Project: 08-25-3311 HCA LSMC CAMPUS EXPANSION
2100 SE BLUE PARKWAY
LEE'S SUMMIT, Missouri 64063

RFI #023: DietEx Footings and Columns

S121

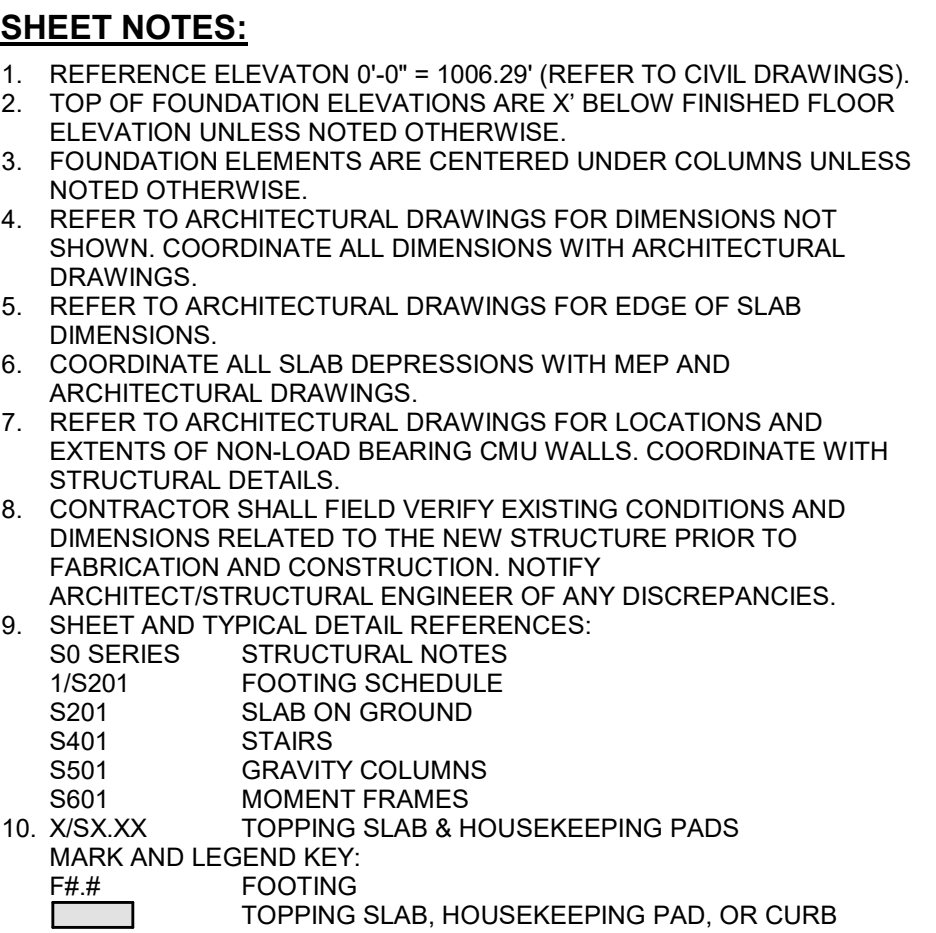
Q1: Design Team to provide distance from top of footing to T/Slab.

1. Drawings referenced in the RFI are not the current drawings. Ref. Sheet notes on S121. Footings are 2ft below FFE.
 2. Columns are located as shown on plan. Center of column is center of footing. Pedestals are as required for architectural finish. Any steel below grade that does not have 2" min. concrete cover shall be protected by mastic coating.
 3. No.
 4. Architect to confirm.
 5. Provide Aluminum Composite Metal Wall Panel per the Architect drawings.
- SDL: Nishith Sardhara Dt: 06/25/2025

S201

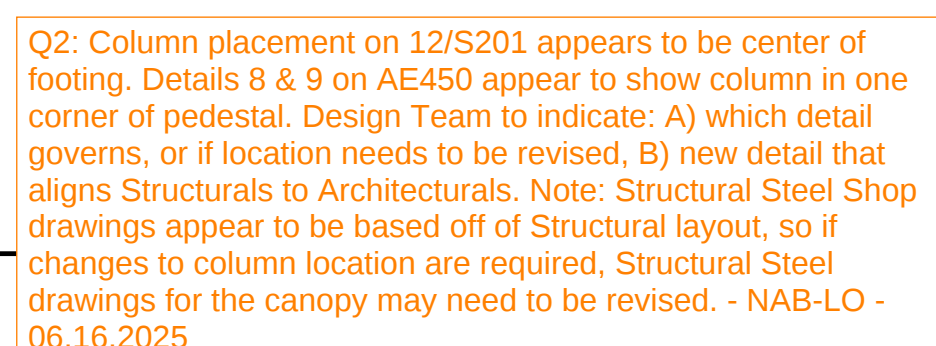
Q2: Column placement on 12/S201 appears to be center of footing. Details 8 & 9 on AE450 appear to show column in one corner of pedestal. Design Team to indicate: A) which detail governs, or if location needs to be revised, B) new detail that aligns Structurals to Architecturals. Note: Structural Steel Shop drawings appear to be based off of Structural layout, so if changes to column location are required, Structural Steel drawings for the canopy may need to be revised.

Q3: Column in 12/S201 appears to be set on footing and has a pedestal placed around it. To simplify constructability, would it be acceptable to set the column on top of the pedestal after the slab has been poured rather than within the pedestal on top of the footing?

Q5: According to detail 8/AE450, the material used to wrap the column is "Alum Composite Metal Wall Panel." This contradicts what is shown here in 12/S201. Design team to identify correct material.

9 CANOPY COLUMN ELEVATION
1 1/2" = 1'-0"

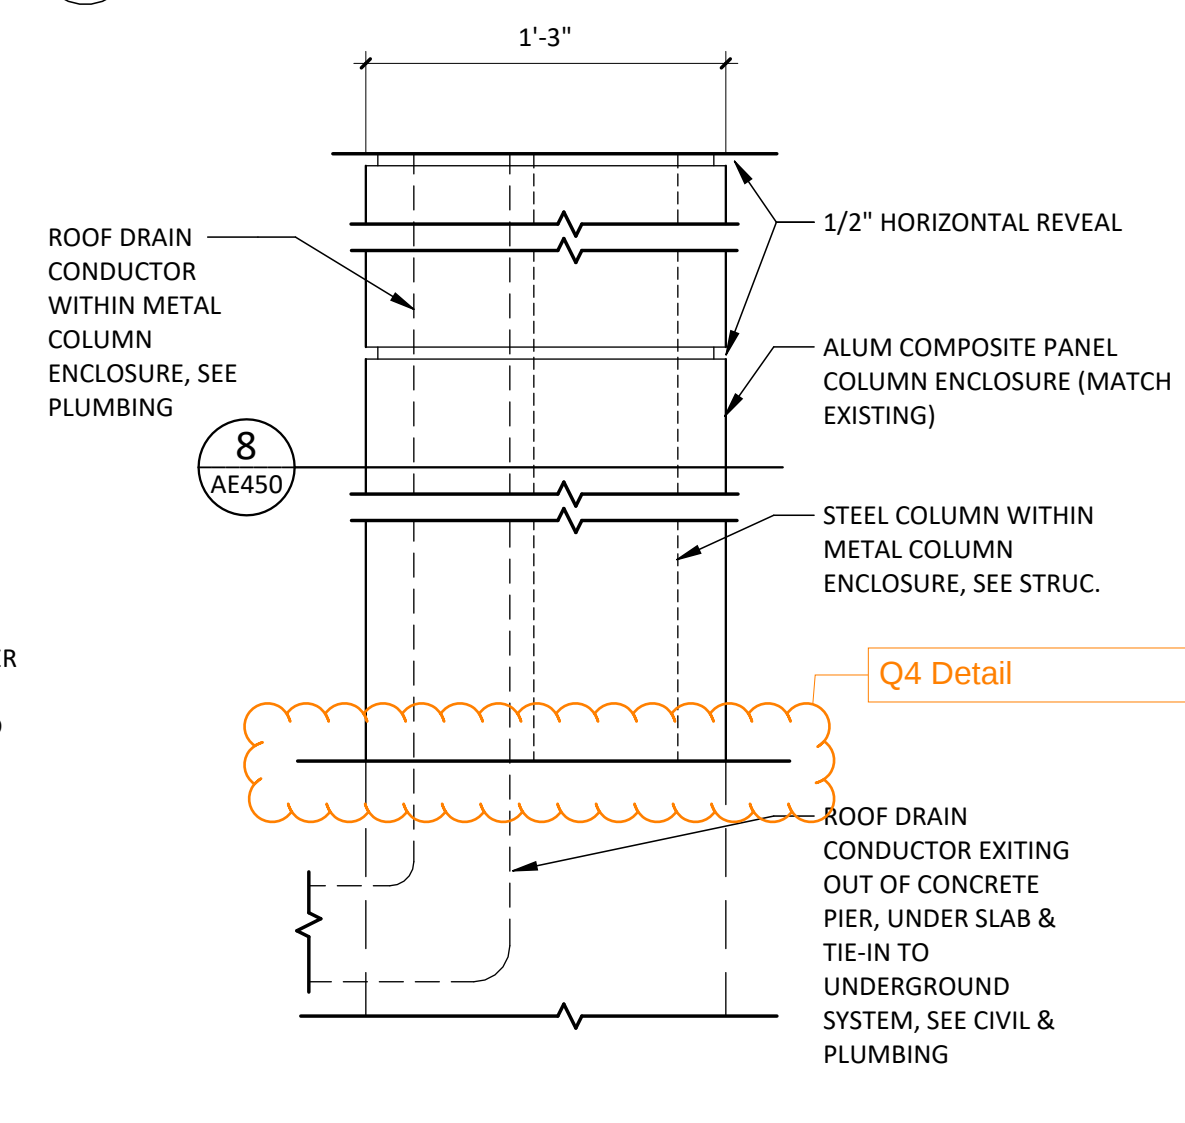
Q4: Panels surrounding the column are shown to be elevated from SOG (slab on grade). Details on 9/AE450 show the panels to be flush with the exterior surface (assumed to be SOG). Design team to provide detail showing how the panel interacts with the exterior surface.

4. Metal panels should sit off of the concrete slab approximately 1/2". This dimension needs to be confirm with the panel manufacturer and their shop drawings. - Matt McDaniel
